Warranty Bulletin

95-08

Date: **April 1995**
 Section: **06**
 Subject: **Evaporator Motor Supply Cable**
 Application:

Model	VIN
Le Mirage "XL" Coach	2P9L3340XM1001883 up to 2P9L33409R1001994 inclusively

FIGURE 1

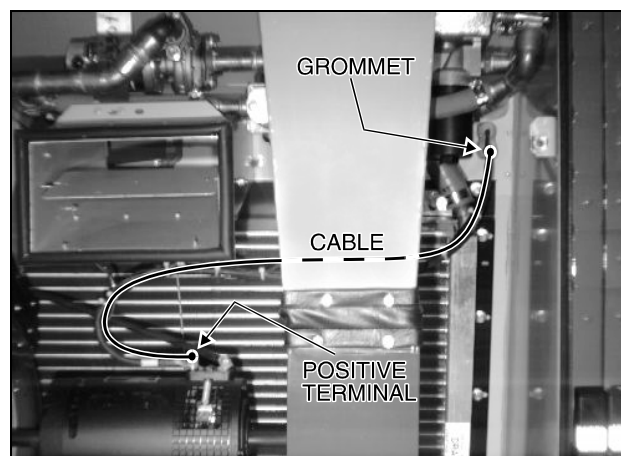
On the above-mentioned vehicles, the routing of the evaporator motor cable is inadequate, and could short-circuit, eventually causing a fire. We ask you to replace the supply cable according to the following procedure.

1. Inside evaporator compartment (on L.H. side of vehicle), locate evaporator motor (Fig. 1). Disconnect cable from positive terminal (L.H. side) from evaporator motor. Cut cable ties and undo retaining clips on cable route. Scrape off caulking around the grommet.

Note: It is important to note the position of cable ties, they all have to be replaced with new ones when installing new cable.
